# NOTICE OF DECISION

**TAX LOT:** Tax Lot 2S1 33BC 001700  
**CASE NO:** LU 2022-020 PUD/SUB  
**DATE OF NOTICE:** March 5, 2024

## Moser Pass

Case File: LU 2022-020 PUD/SUB  
Final Development Plan

**PARK EXHIBIT**

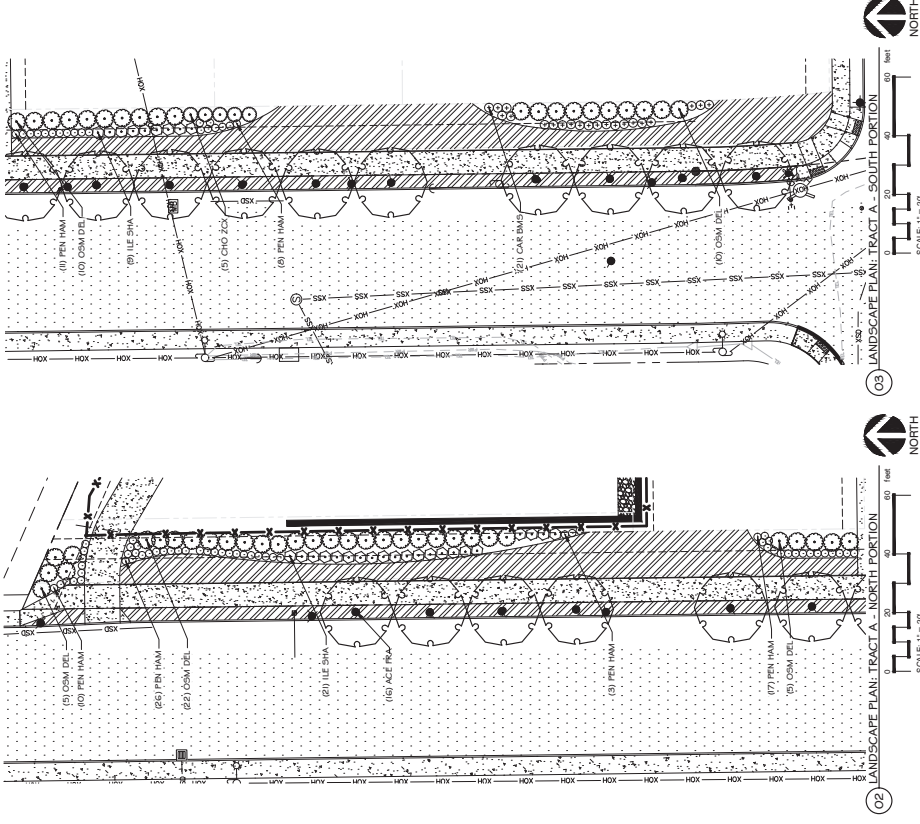
13. Prior to Final Development Plan Approval, a new park identified as Tract F shall be provided in the location of Lots 30 – 32. The design of the park and amenities described below shall be owned and maintained by the HOA unless indicated otherwise. The park and amenity design shall receive approval by the Planning Commission as part of the Final Development Plan

- d. Park shall include a sports court / facility based on an identified need or community desire in the 2021 Parks Master Plan.

- g. Park shall include a new restroom to match the existing restroom at Cannery Square, or a similar design approved by the Planning Commission. The developer shall be responsible for the installation of underground electrical and plumbing and construction of a concrete pad in the final location of the restroom. The City shall be responsible for purchasing, installing, and long-term maintenance of the restroom. The City shall be responsible for setting the hours of operation, cleaning, and maintenance schedule of the restroom.

As previously noted, the preliminary plans showed Tract E as a pedestrian path. The pedestrian path was removed as an open space “Tract” and is now reflected as a pedestrian easement on the plat. The new community park in now considered Tract E and the proposal does not have a Tract F.

**FINDING:** Based on the above discussion, this condition is met.

# Part of Exhibit A, Landscape Plans

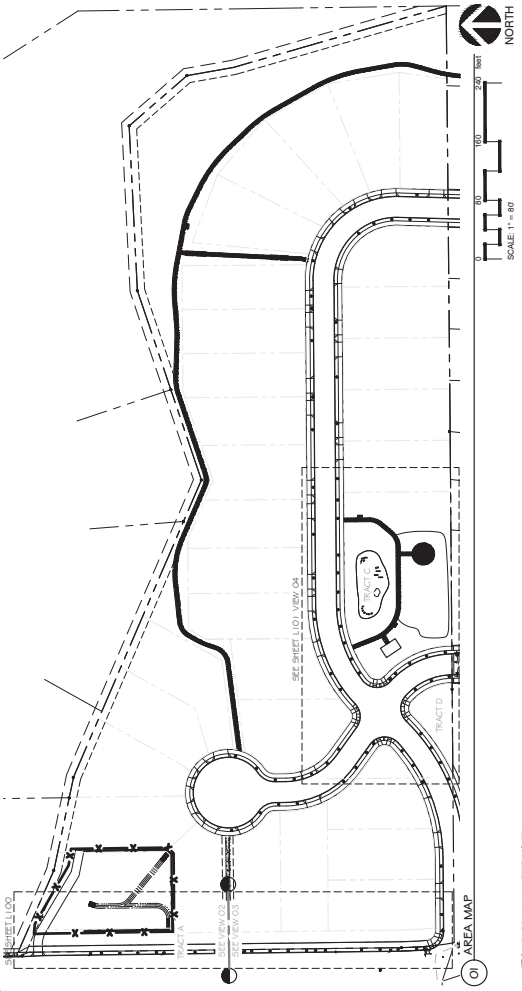
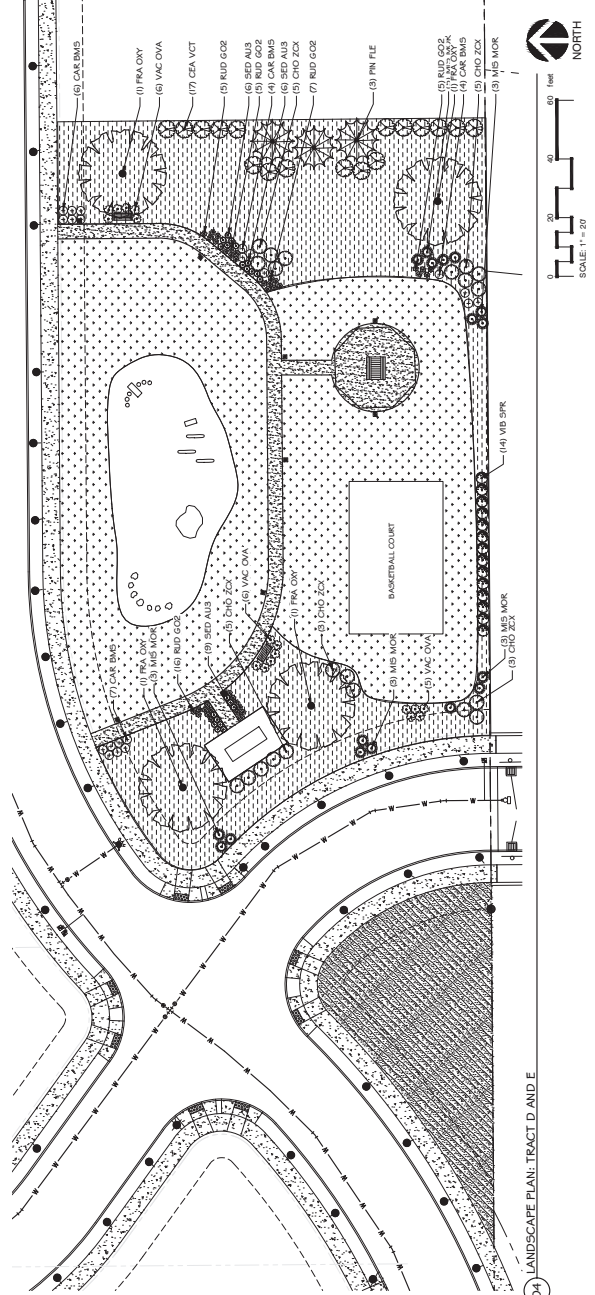
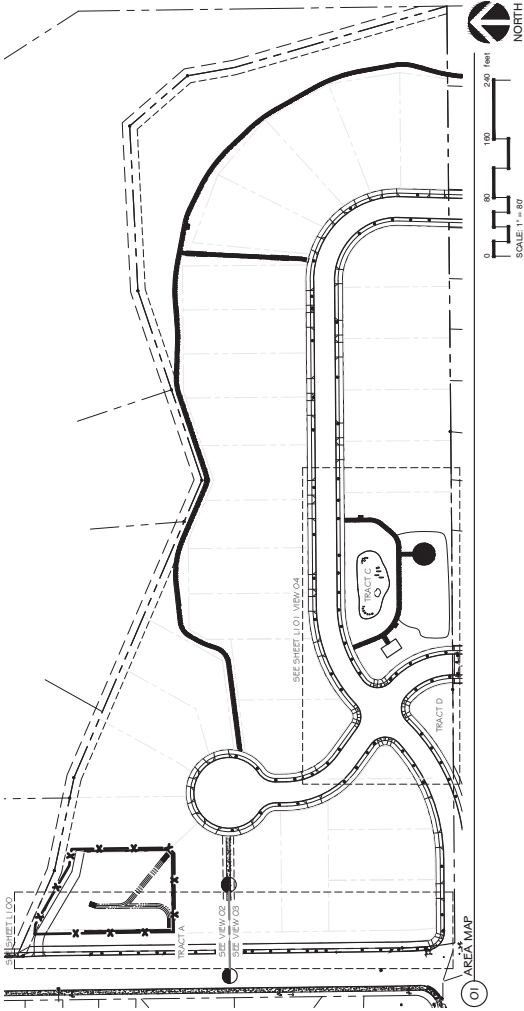
**ANALYSIS:** Sheet L101 of the Applicant's Exhibit 2 includes trees and landscaping as part of the community park.

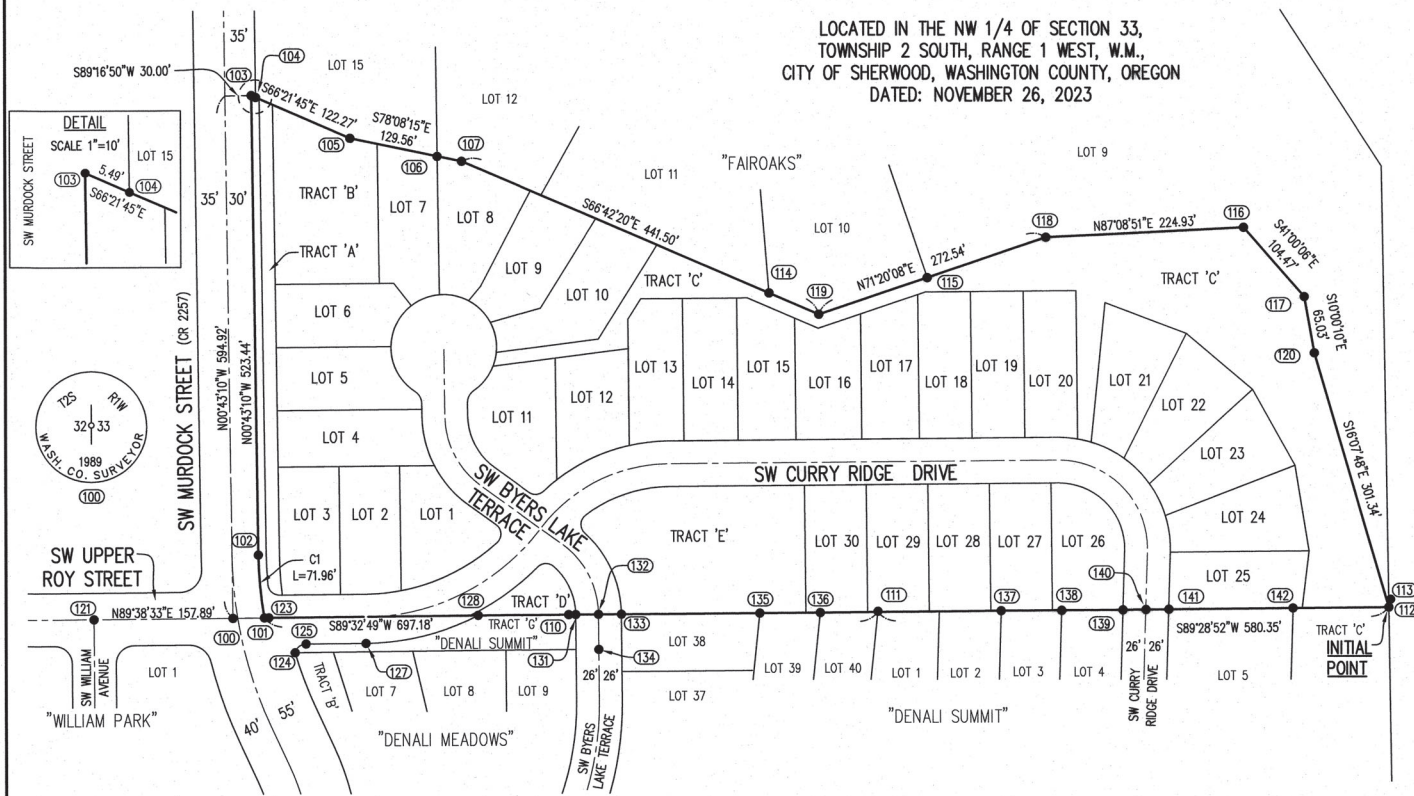
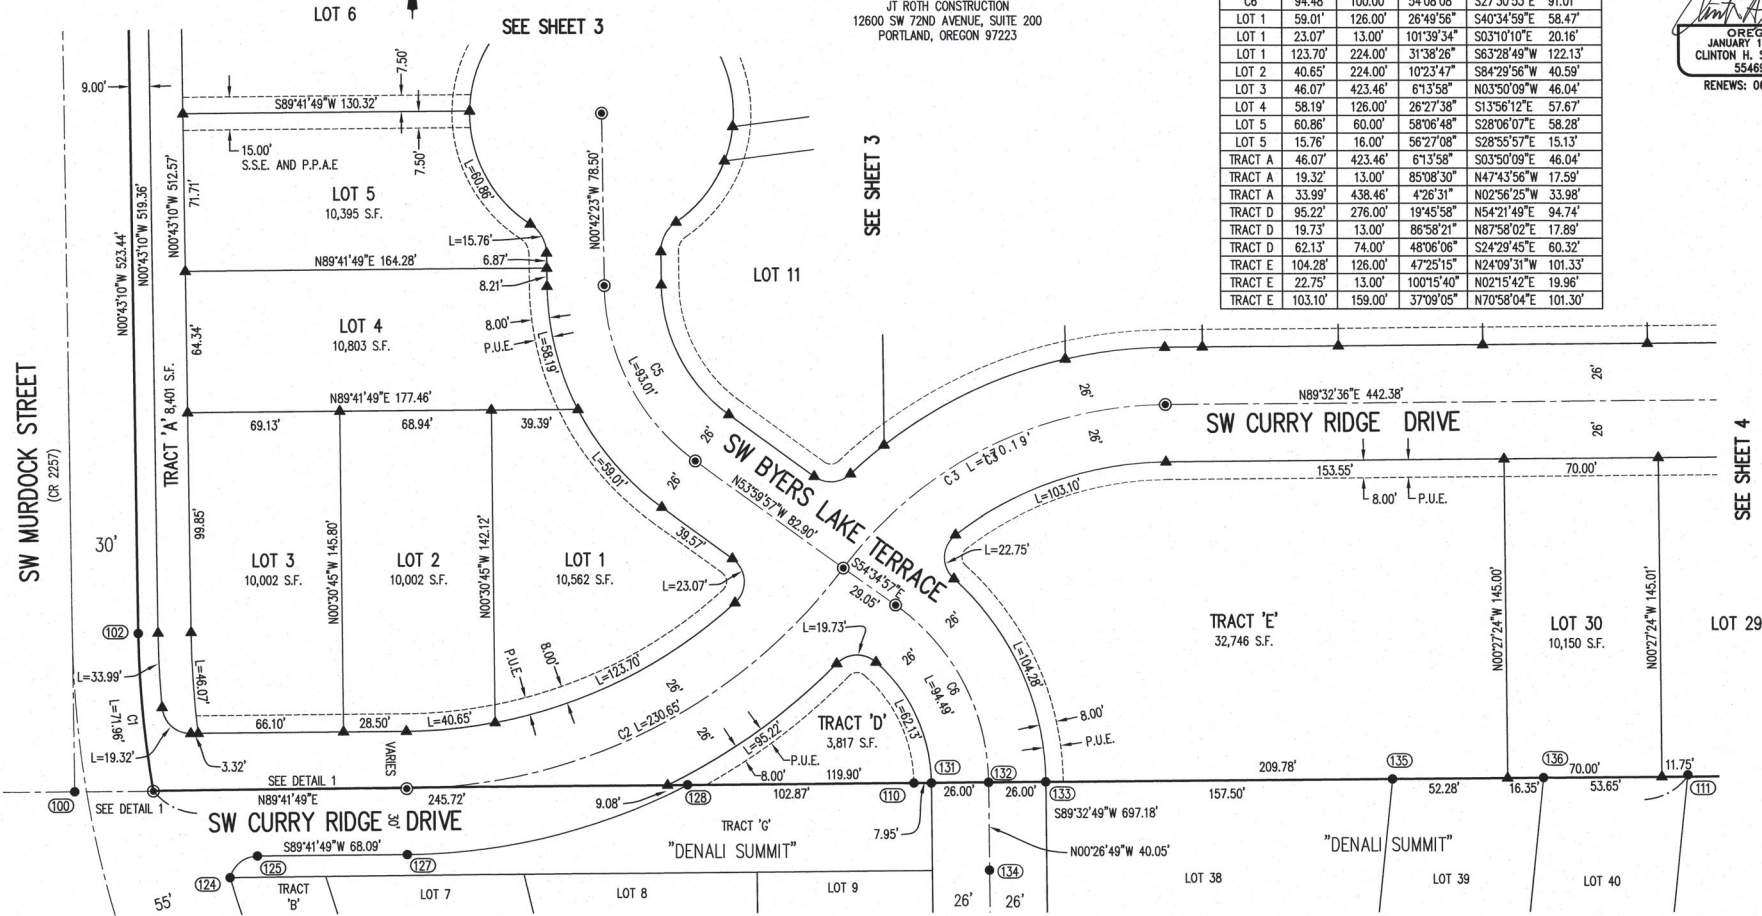
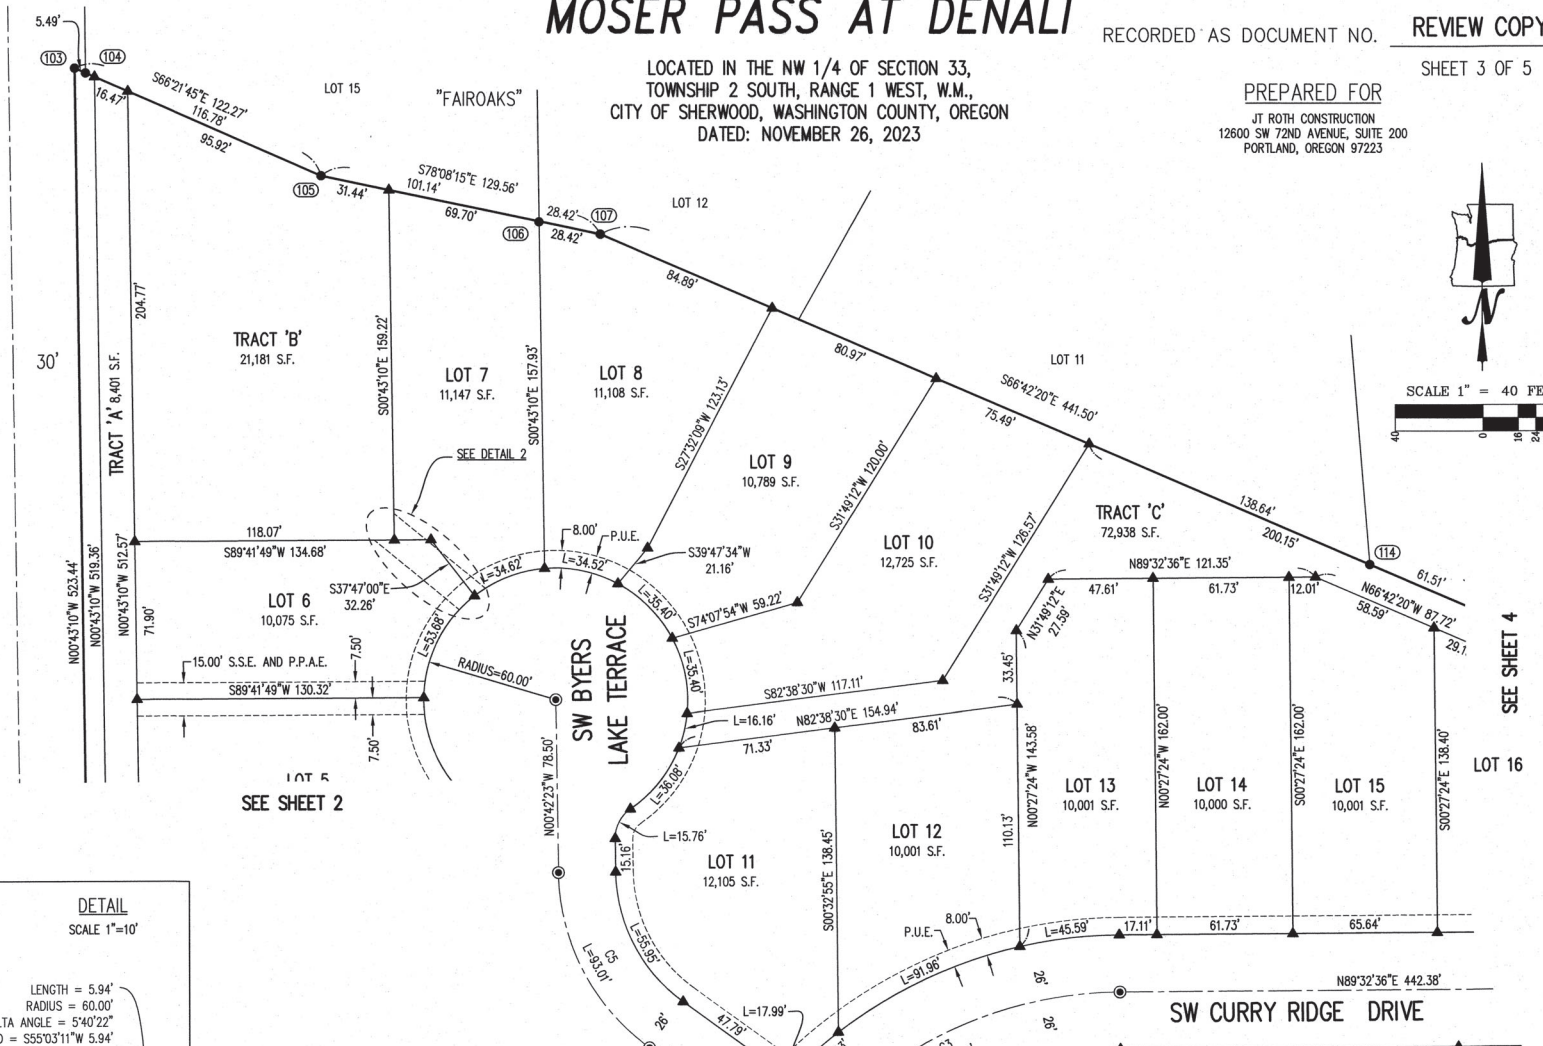
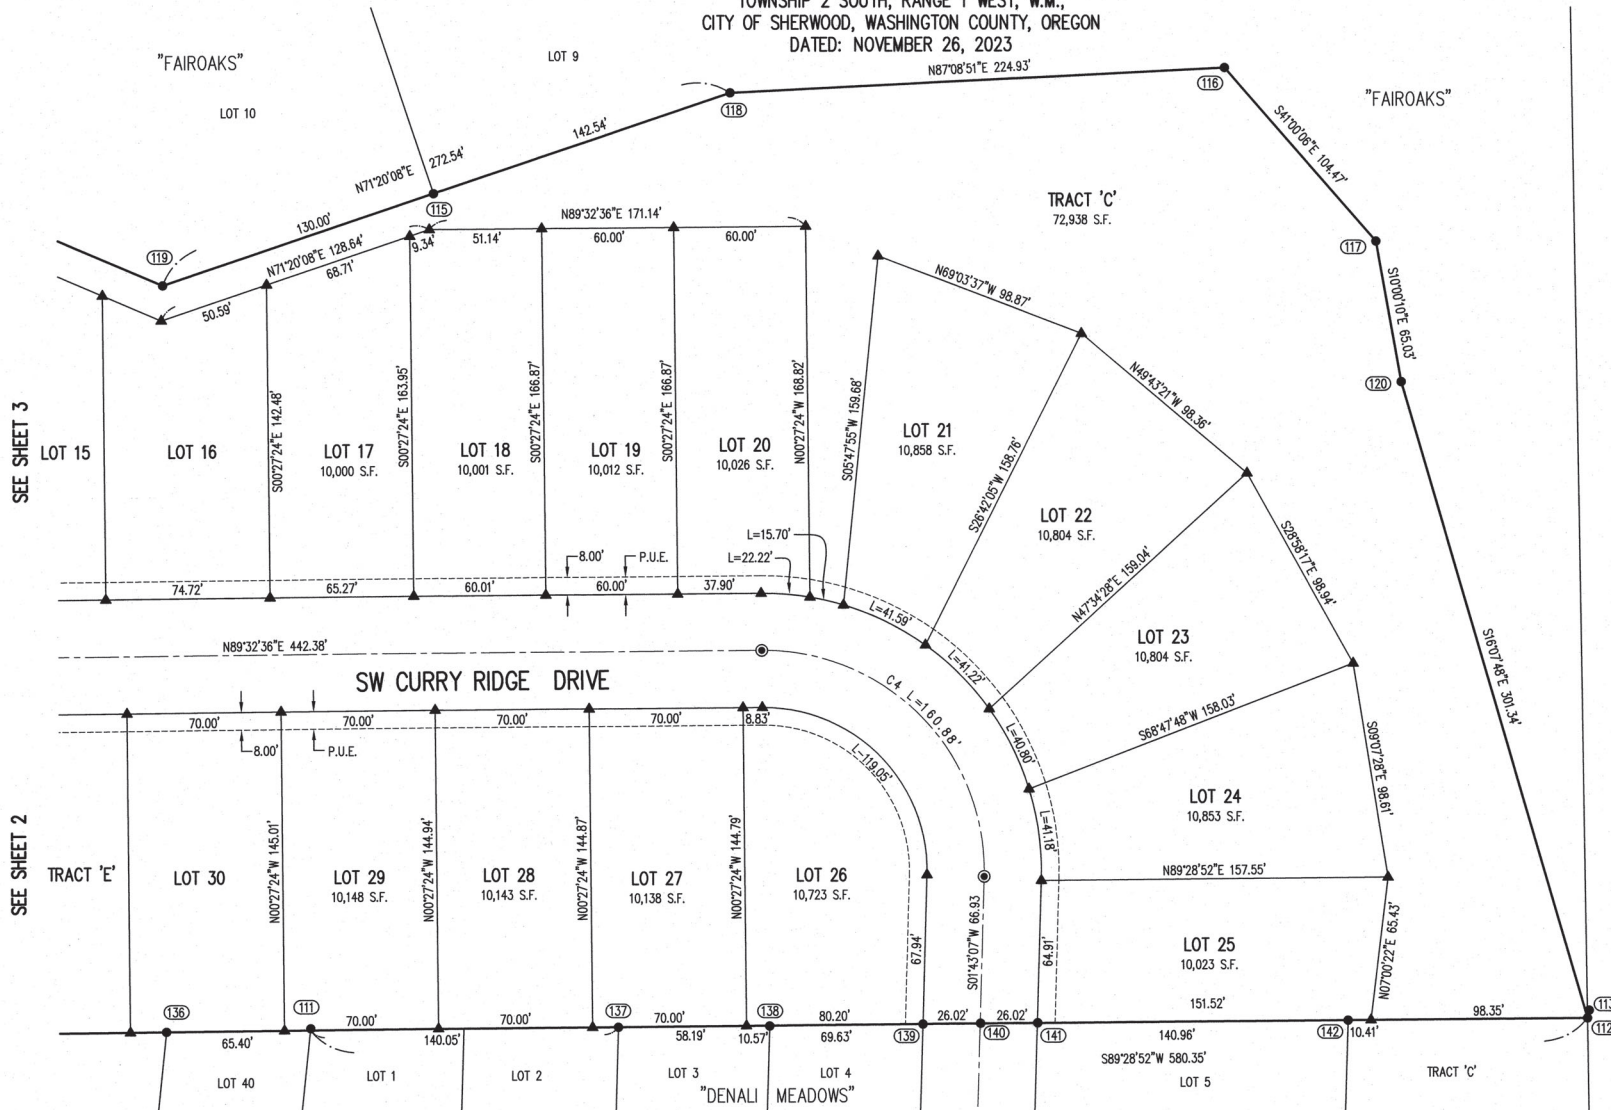
1. Prior to Final Plat and Final Development Plan approval, provide a revised plat that demonstrates how the minimum lot depth and minimum lot width at front property line standards are met.

**ANALYSIS:** The minimum lot depth for the VLDR-PUD is 80-feet and minimum lot width at front property line is 25-feet. Per the submitted Plat, Applicant's Exhibit 4, all proposed lots (Lots 1-30) meet the minimum lot depth and lot width.

**FINDING:** Based on the discussion above, this condition is met.
